**APPENDIX R:
DOCUMENTATION OF CI CONSULTATIONS
HAVING OCCURRED
CASE 10-T-0139**

Champlain Hudson Power Express

**Champlain Hudson Power Express
Upland Co-Located Infrastructure
Fact Sheet**

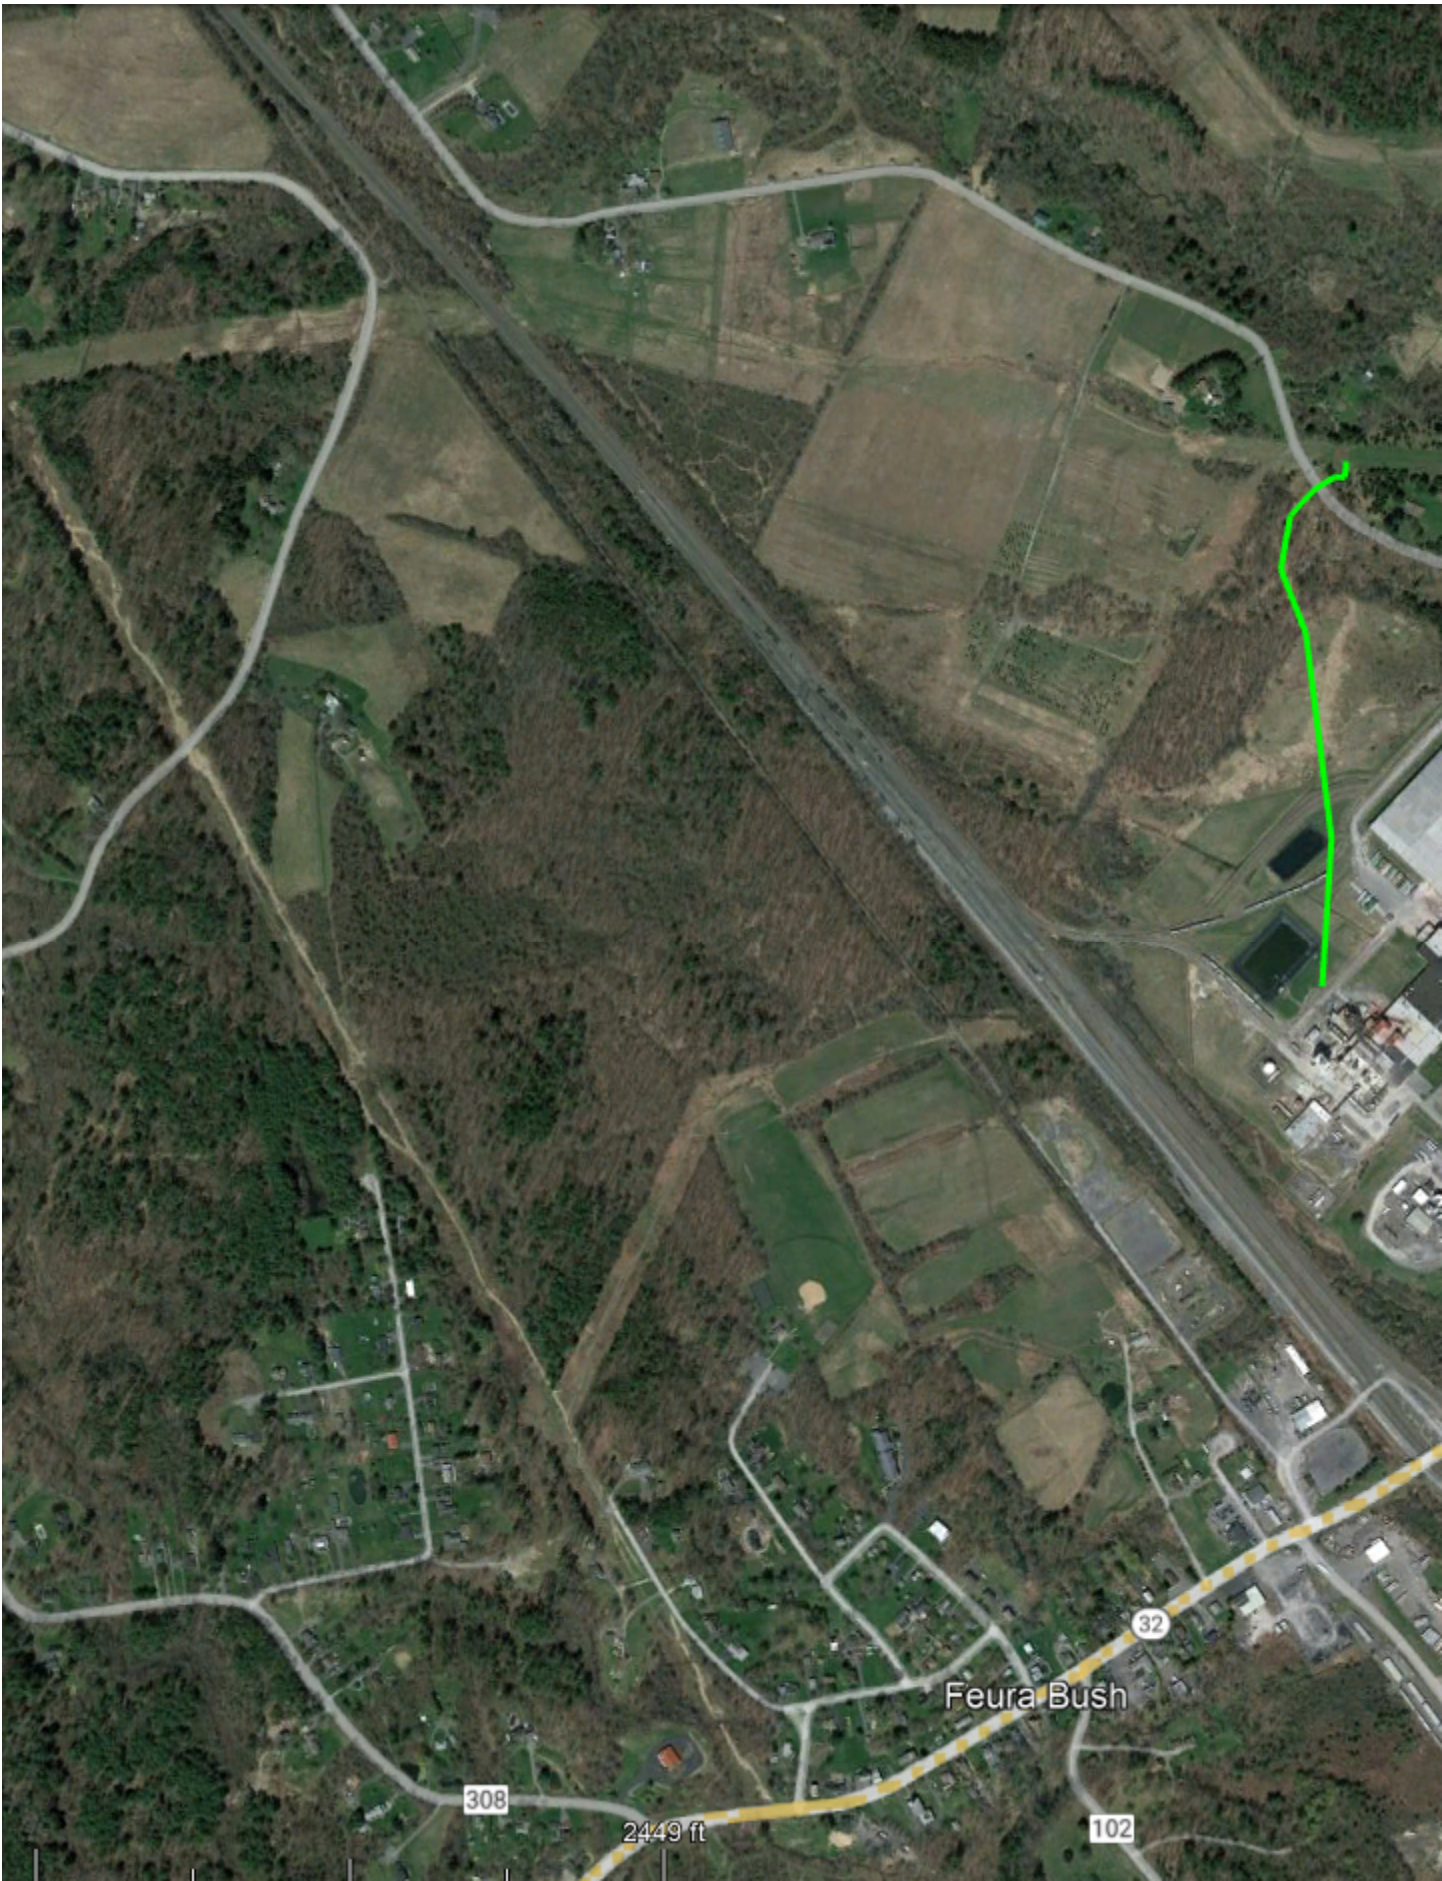
Based on our review of the plan set you sent, it looks like you guys will be running on the other side of the RR and would not impact our pipeline easement. Our gas line runs along the route shown below. Let me know if our interpretation is correct.

Your interpretation sounds correct. The thin red line below is the CHPE alignment. It changes side of the RR approximately due west of your facility. Please let me know if you have more questions/comments/need for analysis.

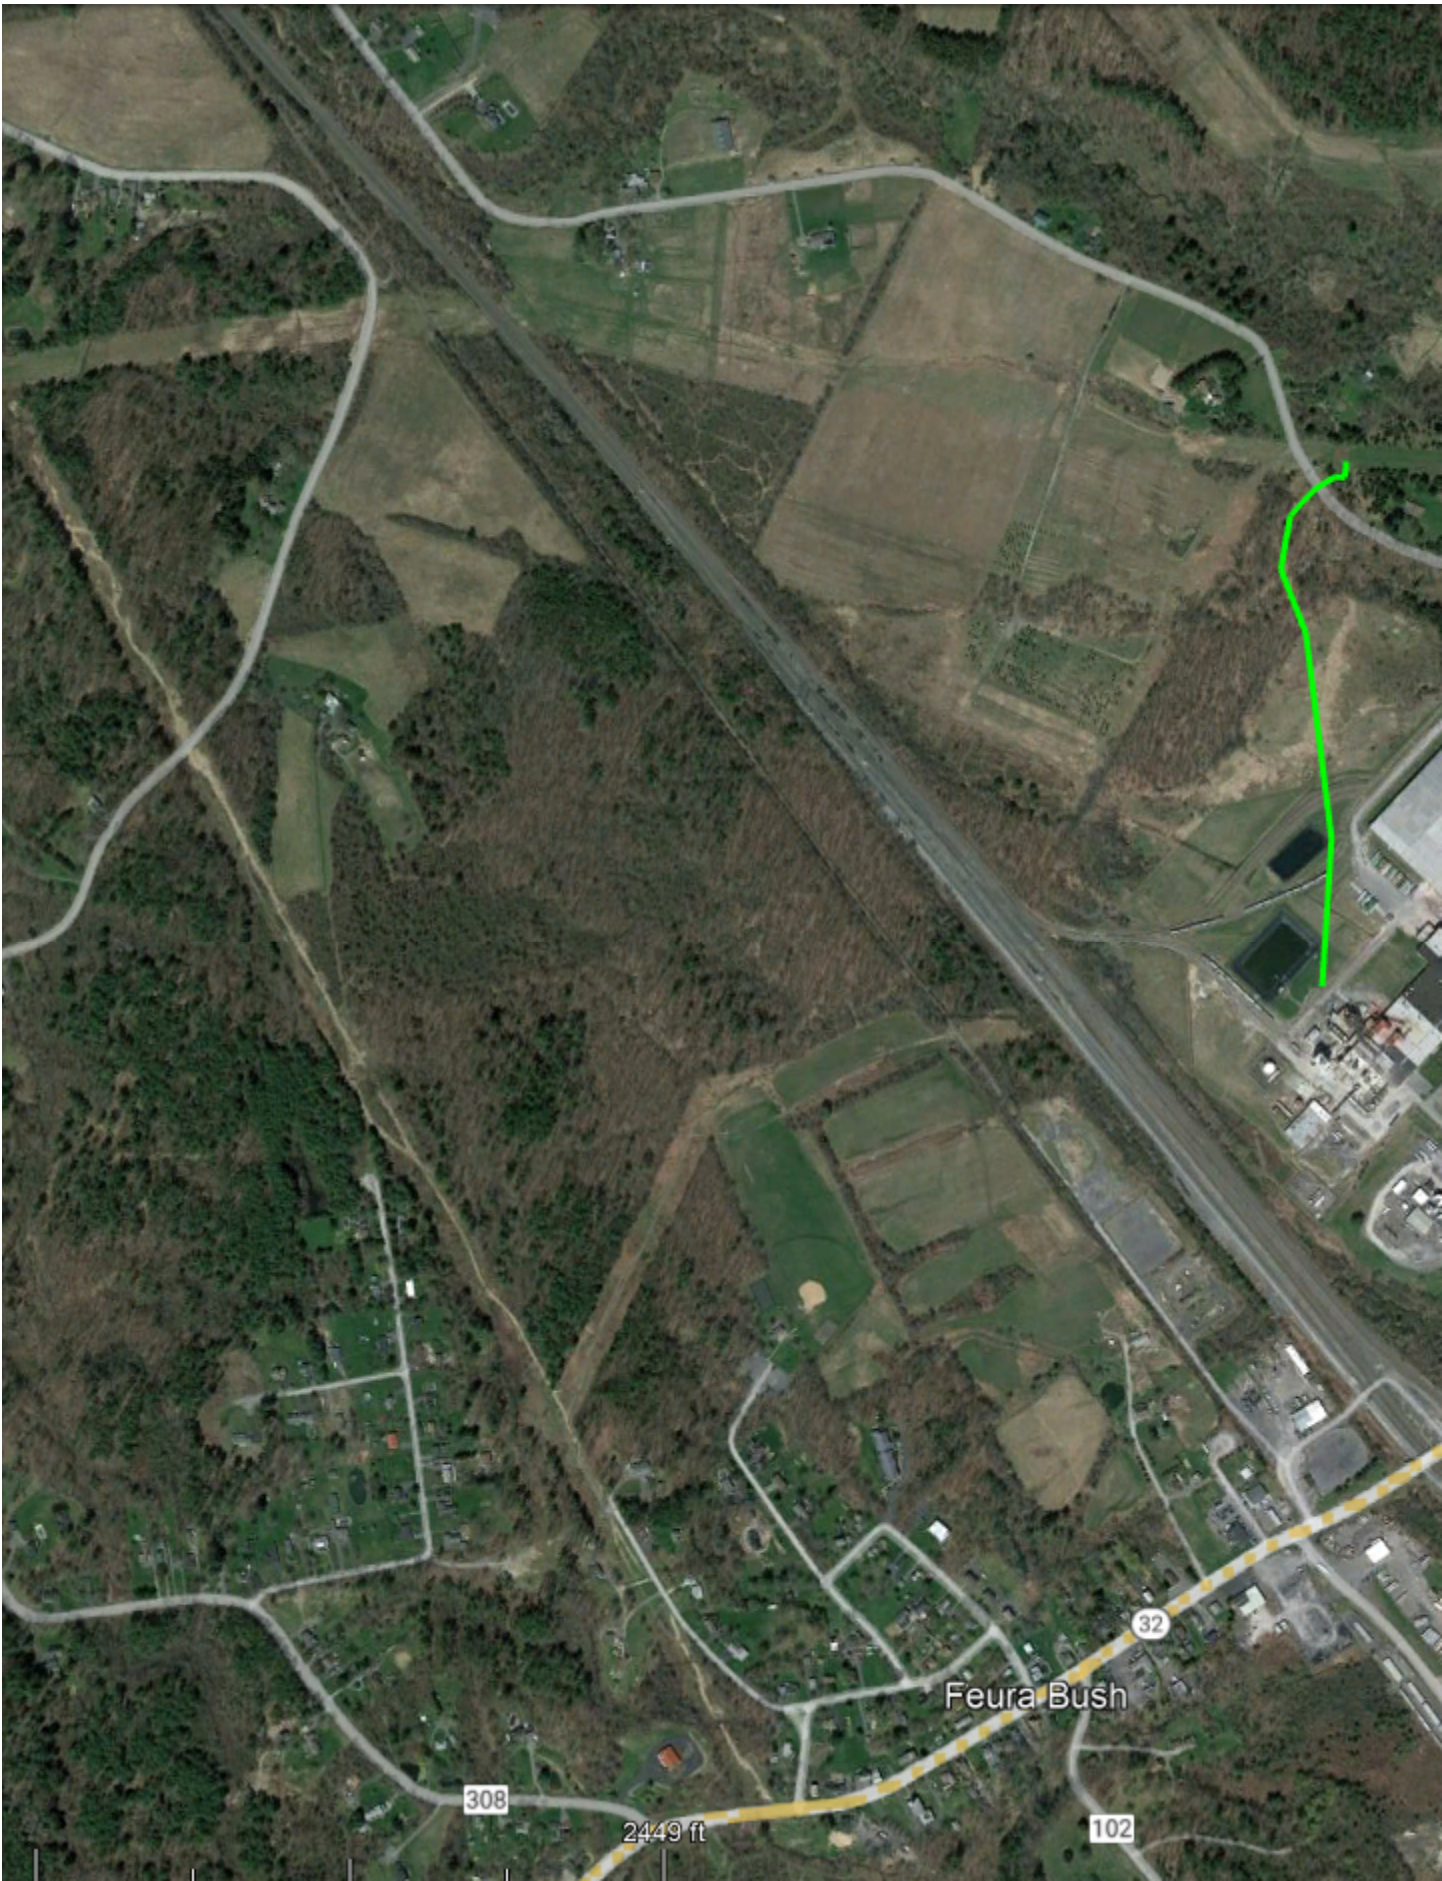
Based on our review of the plan set you sent, it looks like you guys will be running on the other side of the RR and would not impact our pipeline easement. Our gas line runs along the route shown below. Let me know if our interpretation is correct.

Your interpretation sounds correct. The thin red line below is the CHPE alignment. It changes side of the RR approximately due west of your facility. Please let me know if you have more questions/comments/need for analysis.
